Project Name: Ada War Memorial Park - New Concession Stand and Shelter House

Intent:

This Addendum provides modifications and clarifications To the Bid Documents dated **September 9, 2025**. Bidder shall ascertain prior to submitting its Bid Form that it has received all Addenda issued and shall acknowledge receipt of each Addendum on the Bid Form.

SHEET
E101

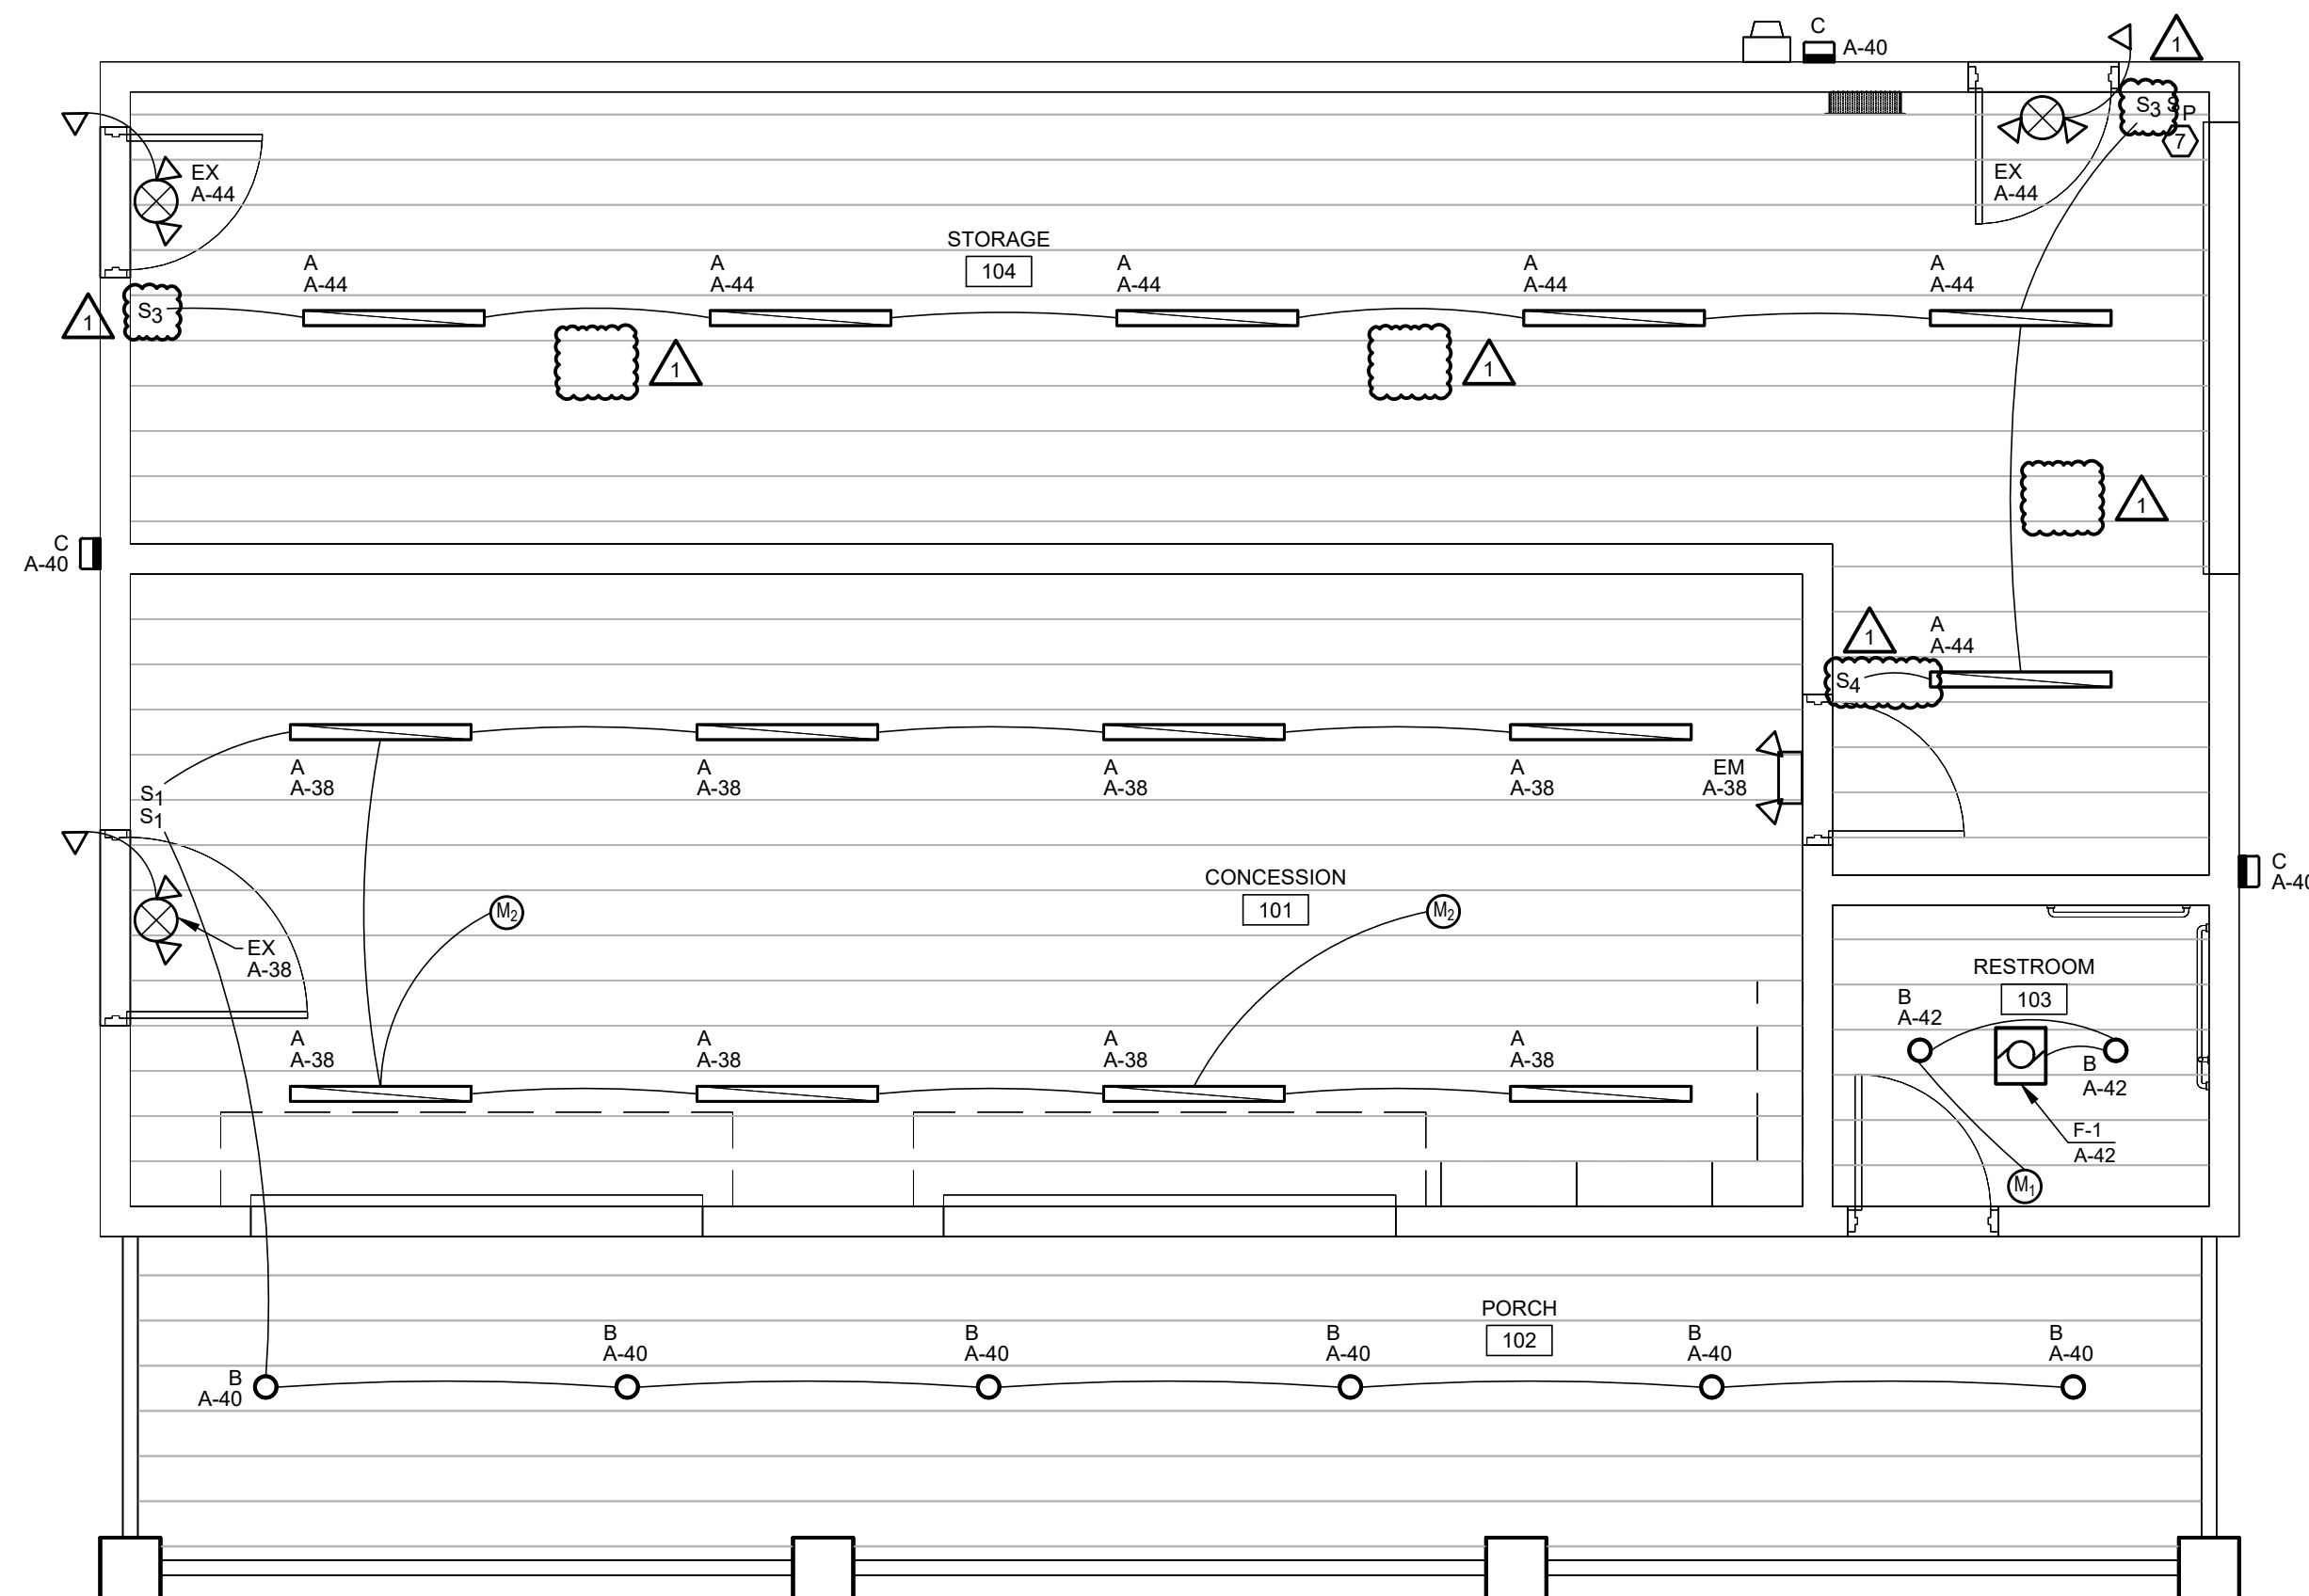
7		SHEET A101 AND DETAIL SHEET SF101/2	CLARIFICATION: Smooth face CMU is acceptable for column location.
8		SHEET A201 AND SHEET A-3	CLARIFICATION: Top course of CMU wall is to be smooth face to accept soffit and frieze board.
Electrical:			
9	REVISED SHEET E101		REISSUE SHEET E101: Eliminated occupancy sensors in Storage 104. Added four-way switch by door and changed single pole switches to three-way switches in Storage 104.
10	REVISED SHEET E601		REISSUE SHEET E601: Added three-way and four-way switches to lighting legend.
End of Addendum 03
